CITY OF SANDPOINT
Infrastructure & Development Services
CONTRACT CHANGE ORDER

Date: 4/24/2024**Travers Park Ph 1- CM/CG****Contractor: Ginno Construction, Inc.**Change Order No: 4Project No: A23-5300-5

Prime Contract Change Order #004: OH Doors, Aprons, Lighting, Sawdust, Paving, Storm Drain

EXTERIOR DETAILS

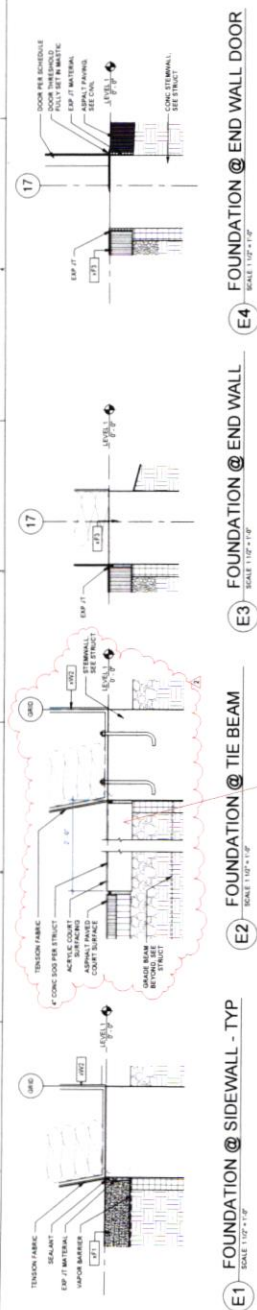
Provide concrete slab on grade 'apron' at 2' depth along east and west sides of asphalt court area per attached modified detail E2/A-511.

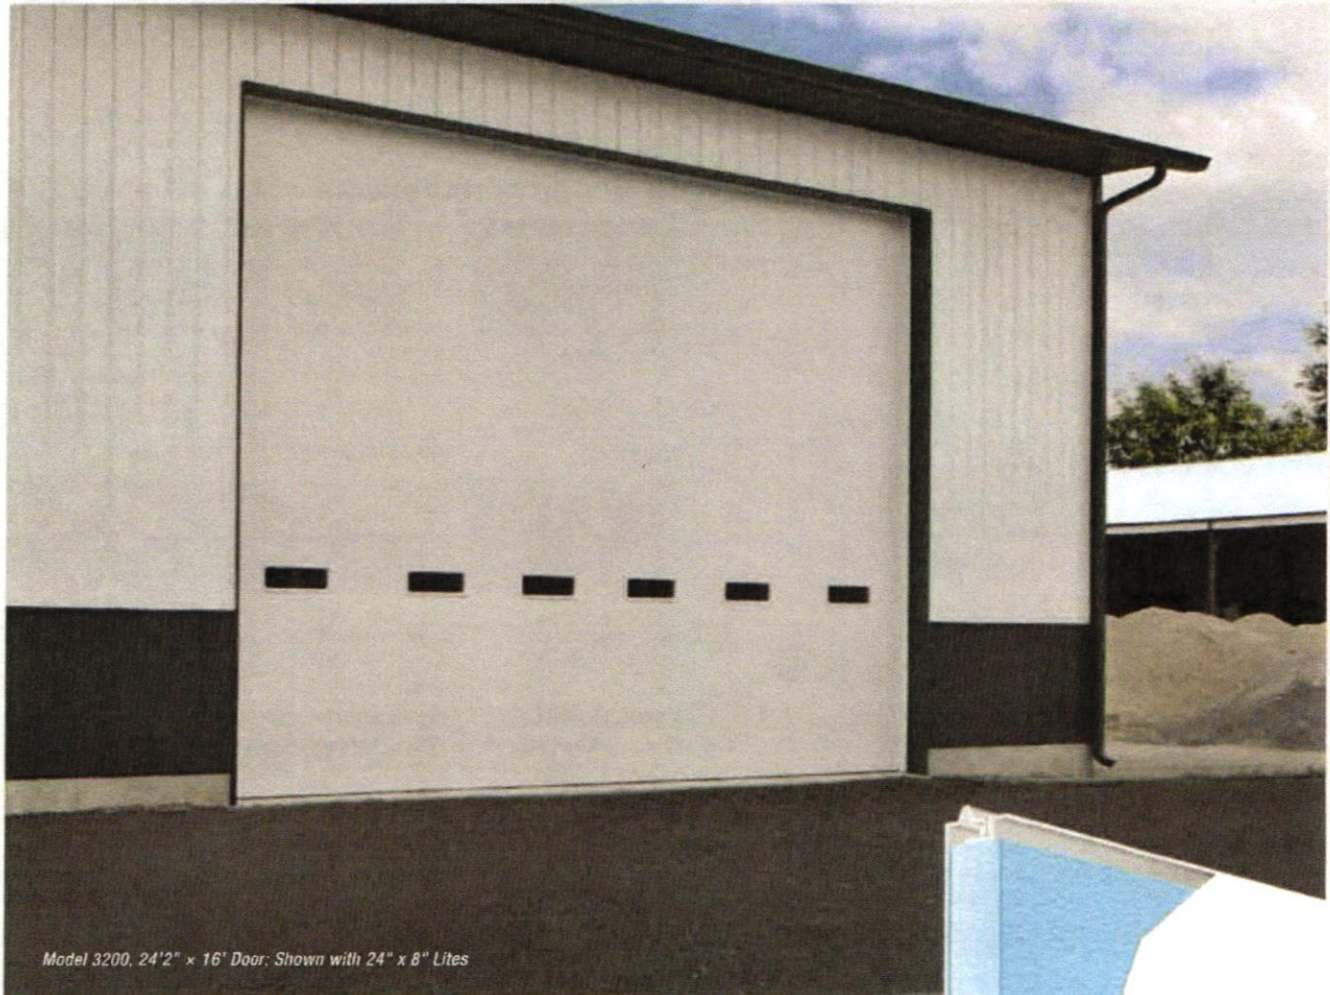
In response to your inquiry regarding the potential for the overhead door(s) to increase in size from 10'x10' to 12'x12', I cannot offer you a complete answer at this time but can offer the following.

You have our drawings, so you can see the opening that is framed in the sidewall for the door currently. There is not a lot of room to move the entire opening upward, but I would say it appears likely that with a change in the track (angle), you could likely find a 12'-t door that will fit.

We would be looking at \$500 +/- for redrafting all the details for a change in OHD size. It would not be until this process was completed that I could also confirm the materials cost impact of the change. I am guessing we could be looking at \$1,000+ per door for modified components, plus freight cost to get the materials to site.

A1 LEVEL 1 FLOOR PLAN
SCALE: 1/8" = 1'-0"

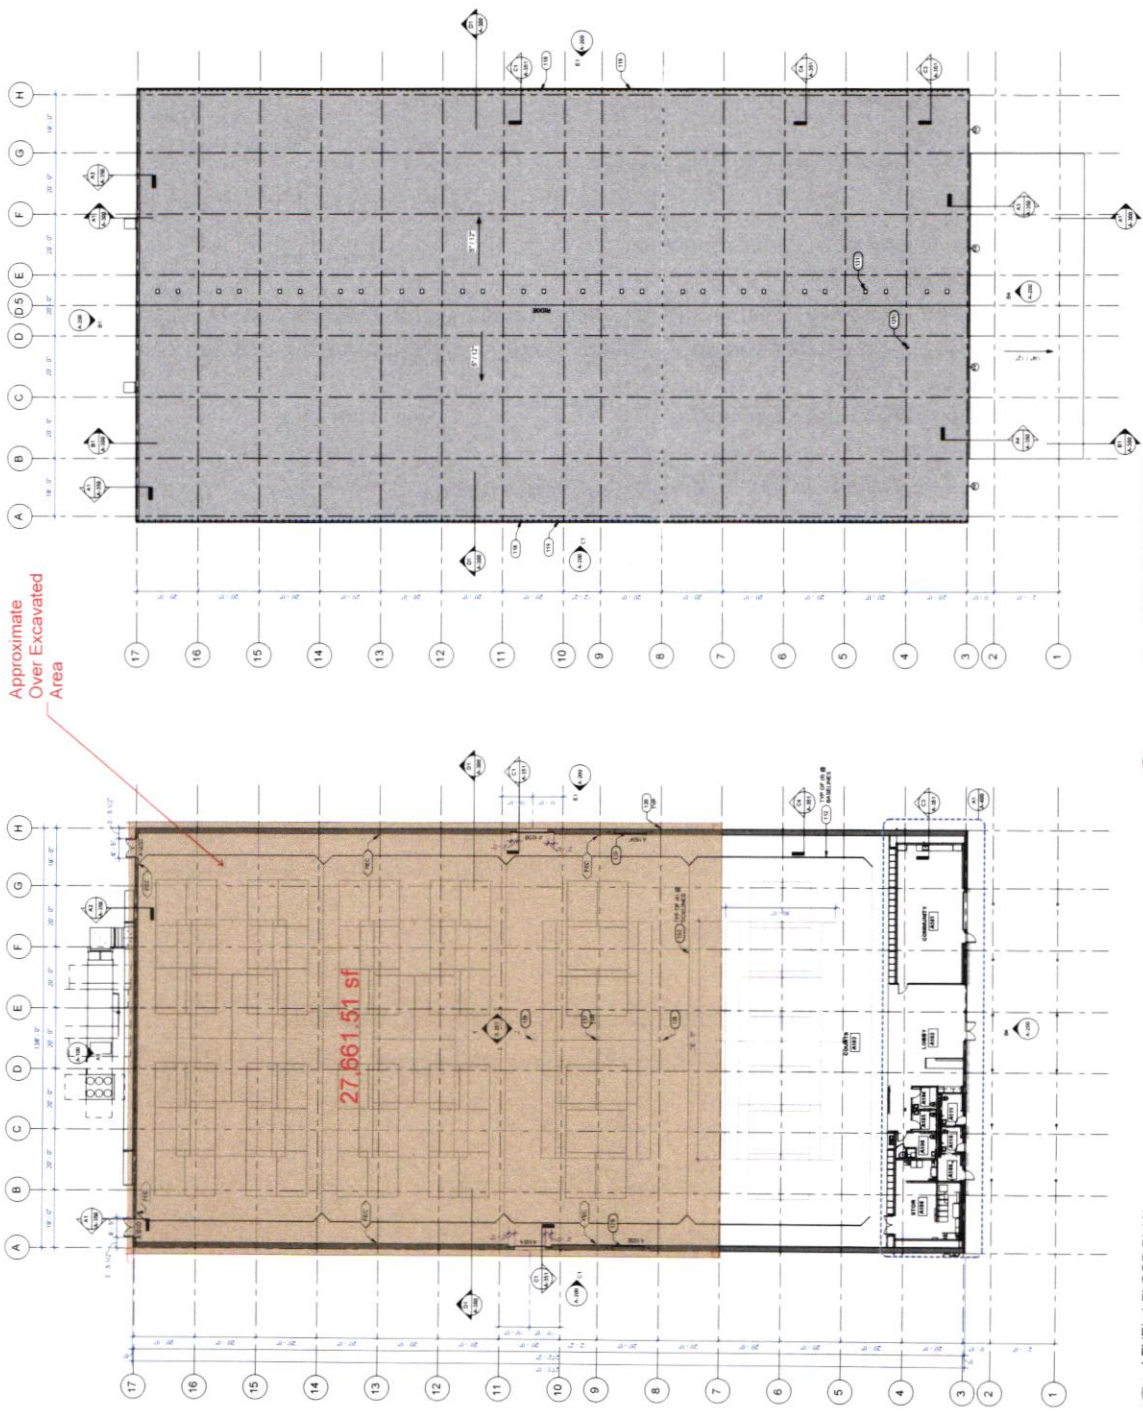
I'm assuming you are planning to haul off all the sawdust, are you asking for pricing purposes?

Yes that's correct, the swell factor is what I'm referring to

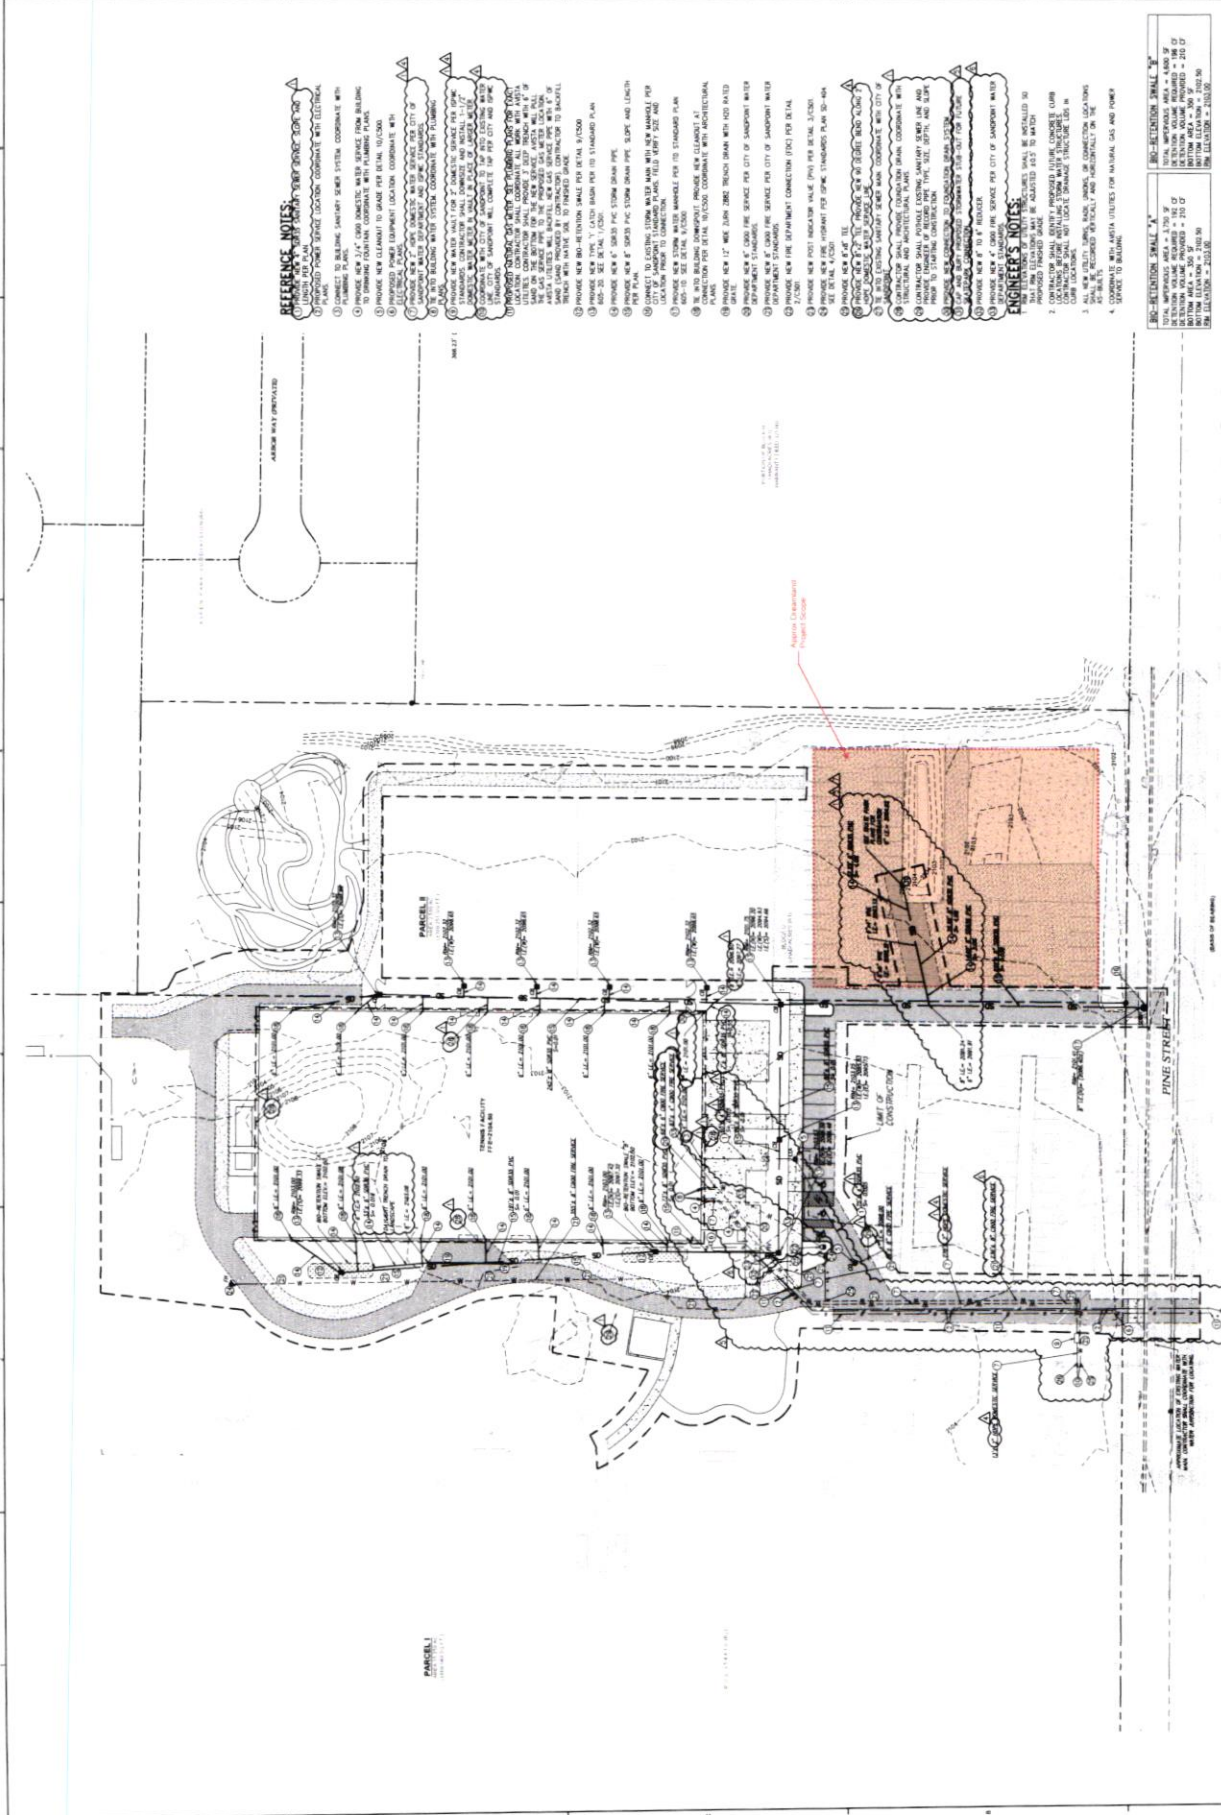
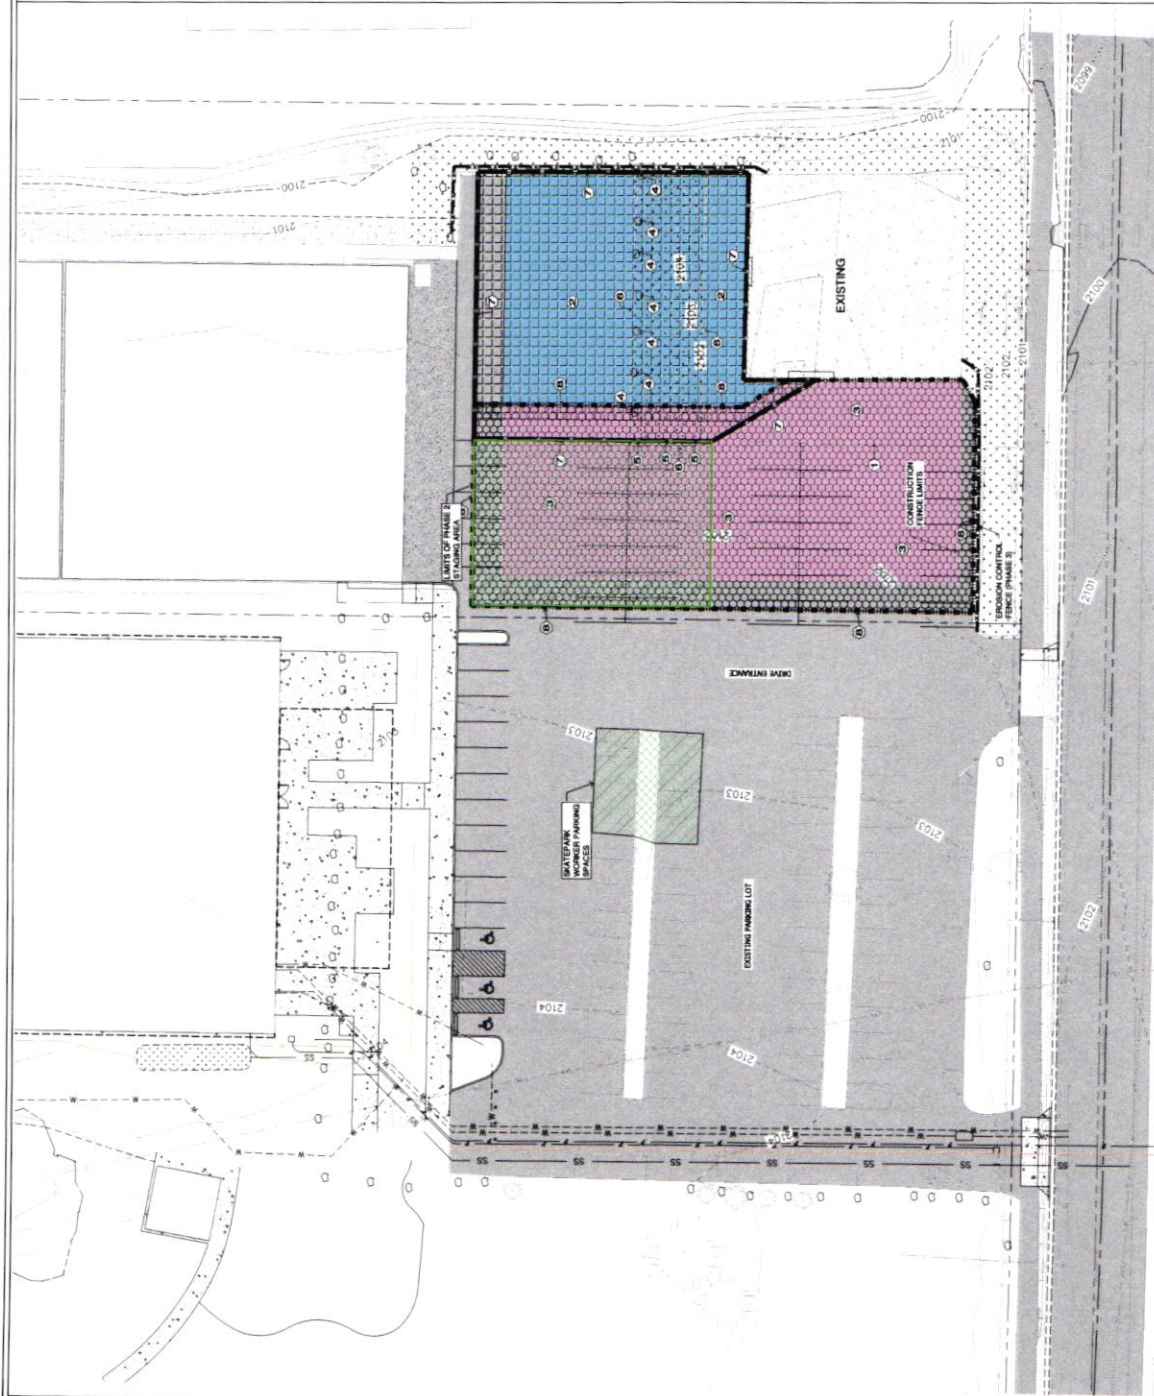
Extend storm drain to meet Phase 1 of skate park expansion per attached revised C-140

QTY/HRS	DESCRIPTION	UNIT COST	TOTAL
100	Extend storm drain for continuation to future skate park per plan C140. Approx 100'. Includes backfill and compaction. (Excludes asphalt patching)	85.00	8,500.00T
	Haul off and dispose of asphalt spoils.	1,000.00	1,000.00T
15	Bedding sand. Delivered	29.00	435.00T
30	Gravel for backfill. Delivered	29.00	870.00T
	Job Site Supplies Used	1,492.60	1,492.60T
